Model: See Affected Units	Apr. 2, 2026
Serial #: N/A	
Product Bulletin # <b>CDS-017 Rev 1</b>	
<b>Alert</b>

## Retrofit – Add Torque Limiting Mechanism to Casing Drive System Link Tilt Assembly

**NOTICE** This document replaces Tesco Safety Bulletin SB036, which is now withdrawn.

860197

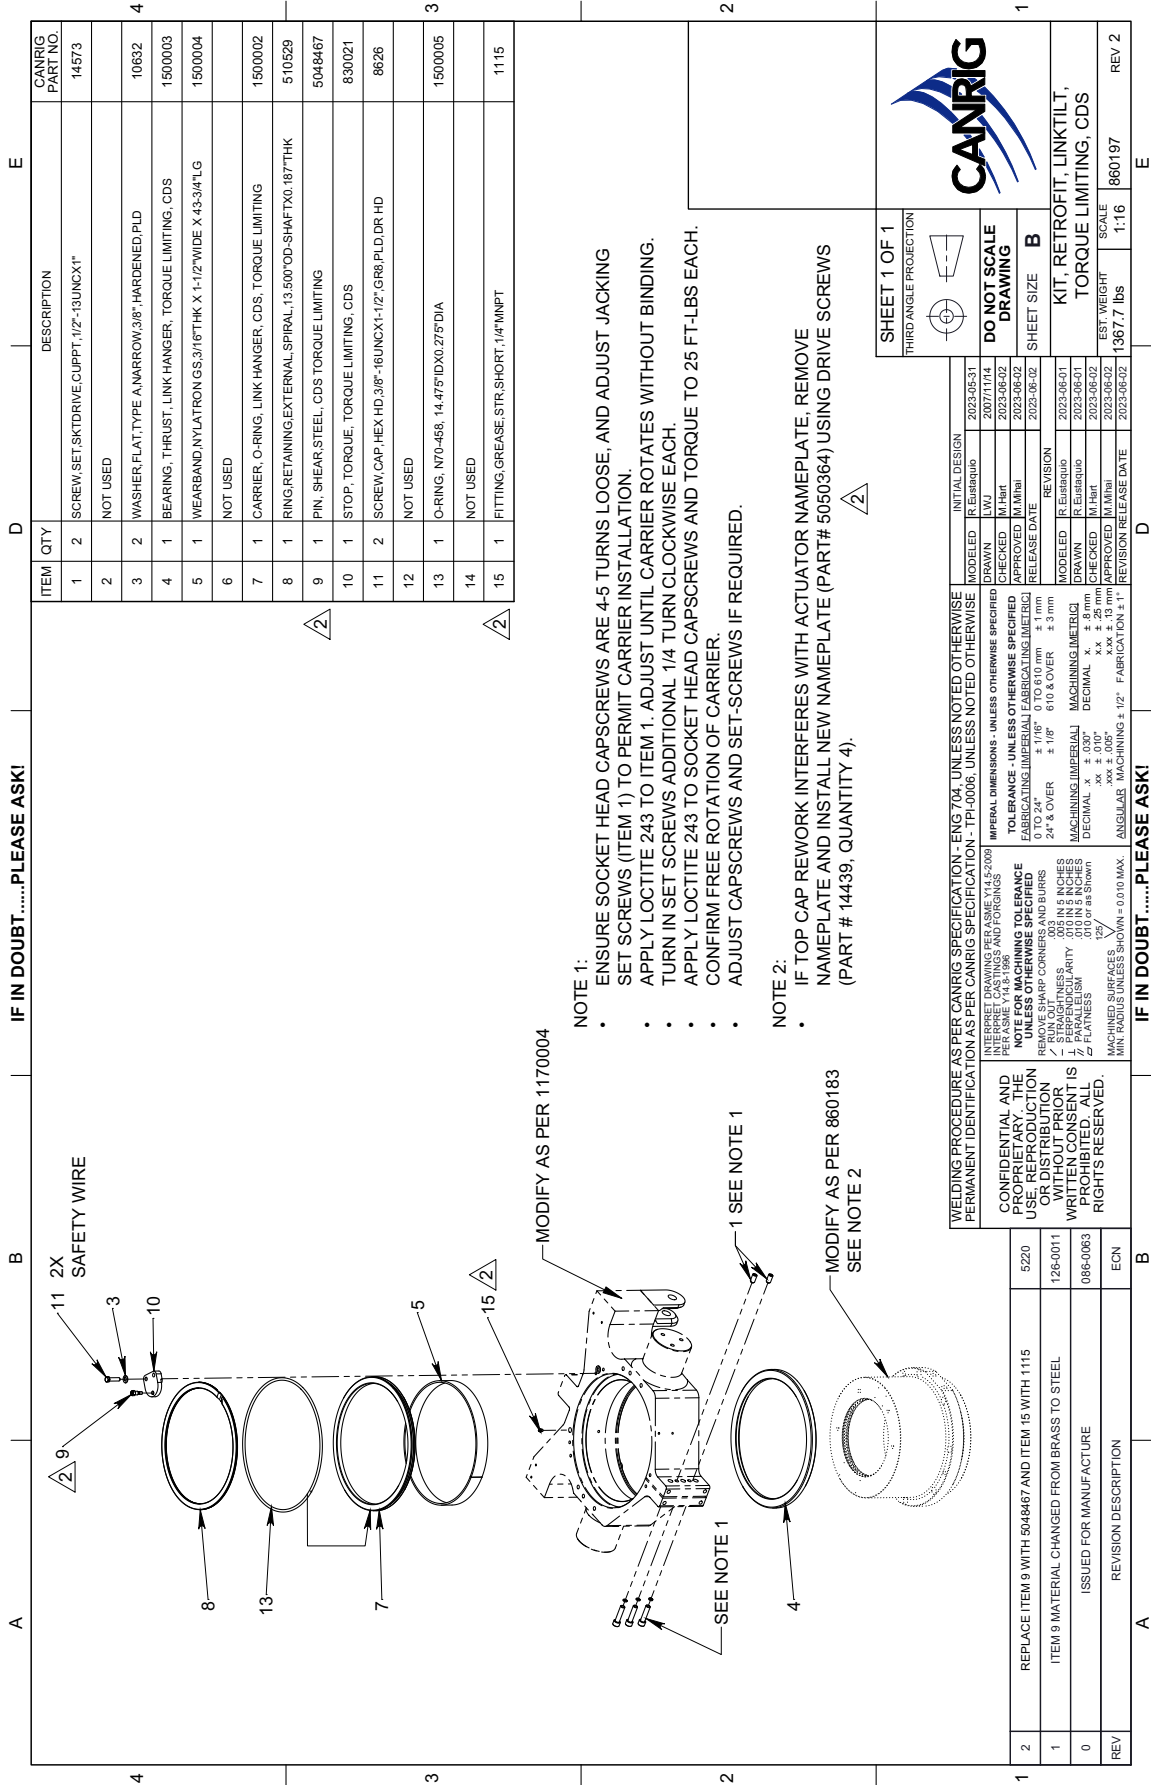
3. After the modification for both carrier and top cap is completed, reassemble the link tilt kit by adding all the parts listed in drawing 860197.
4. See Note 2 in drawing 860197, if the modified top cap interferes with actuator nameplate, replace the old nameplate with P/N 5050364 using four (4) screws P/N 14439.

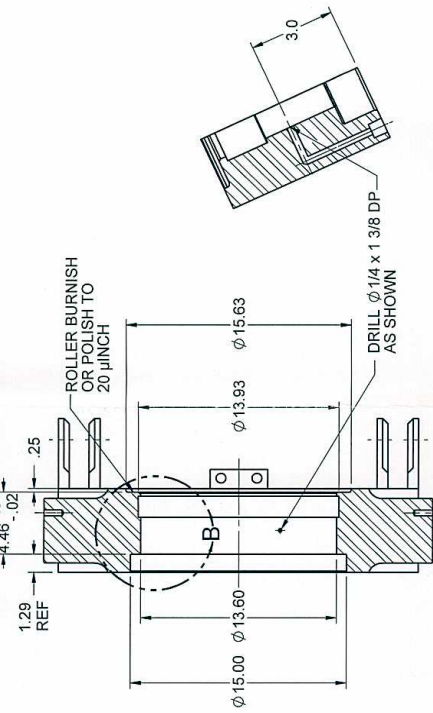
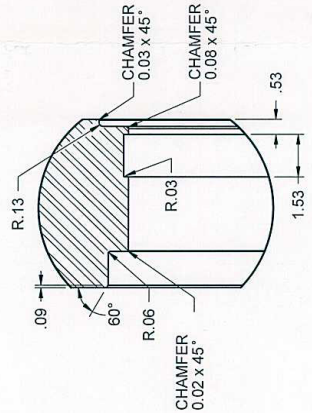
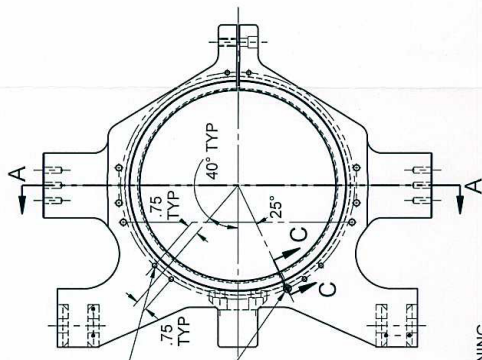
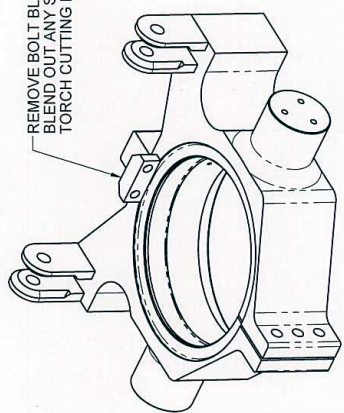
Modify carrier (P/N 540339 or 16057) as per drawing 1170004 (drawing attached).

- a. Obtain an existing link tilt hanger carrier, part #540339 or part #16057.
- b. Remove the bolt block by machining as shown in drawing 1170004. Blend out any sharp edges. Torch cutting is not permitted.

- c. Drill and tap the six  $\text{Ø}3/8" - 16 \text{ UNC} \times 1"$  deep holes as shown in drawing 1170004.
- d. Drill and tap the  $\text{Ø}1/4" - \text{NPT} \times 3"$  deep hole as shown in drawing 1170004.

- e. Cross drill the  $\text{Ø}1/4" \times 1-3/8"$  deep hole as shown in drawing 1170004.
- f. Open up the bore of the carrier to  $\text{Ø}13.60"$  as shown in drawing 1170004.

- g. Open up the top 1.29" (REF) of the bore to  $\text{Ø}15.00"$  as shown in drawing 1170004.
- h. Open up 1.53" of the bore to  $\text{Ø}13.93"$  as shown in drawing 1170004.

- i. Spot face the bottom 0.25" of the bore to  $\text{Ø}15.63"$ .
- j. Roller burnish or polish the bottom spot face to 20  $\mu$  inch as shown in drawing 1170004.

- k. MPI machined areas. Bring any indications found to the attention of Canrig Engineering.
- l. Paint TESCO yellow as per Canrig ENG 713.

REMOVE BOLT BLOCK BY MACHINING.  
BLEND OUT ANY SHARP EDGES.  
TORCH CUTTING NOT PERMITTED.

DRILL .05/16 x 1 DP  
TAP 3/8 - 16 UNC  
6 PLCS ON 16.25 BCD

- DIMENSIONS SHALL BE TO UNLESS OTHERWISE NOTED.		PUBLICATION: 860183		REV: 0	
- DIMENSIONS SHALL BE TO UNLESS OTHERWISE NOTED.		9" TO 24" - 8118		PAGE: 1 OF 1

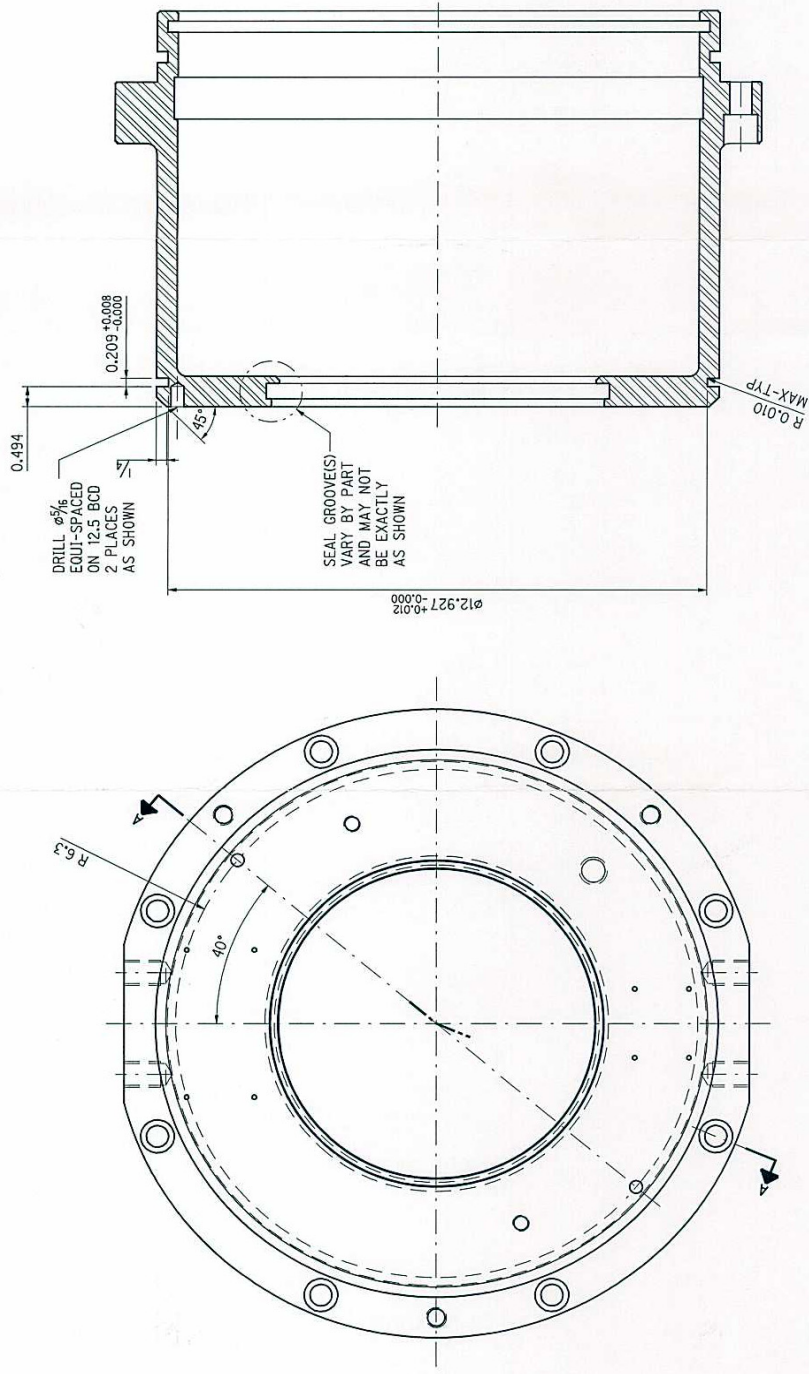
Modify top cap (P/N 820052 or 15258) as per drawing 860183 (drawing attached).

- a. Obtain an existing top cap, part #15258 (Mark 1) or part #820052 (Mark 2).
- b. Add the retaining ring groove ( $\text{Ø}12.927" \times 0.209"$ ) as shown in drawing 860183.
- c. Add the two  $\text{Ø}5/16" \times 0.494"$  deep drilled holes as shown in drawing 860183.
- d. MPI machined areas. Any indications found will be dispositioned.

e. Zinc phosphate and oil machined areas by immersion process to obtain 1000 – 3000 mg per sq. ft. coverage after MPI.
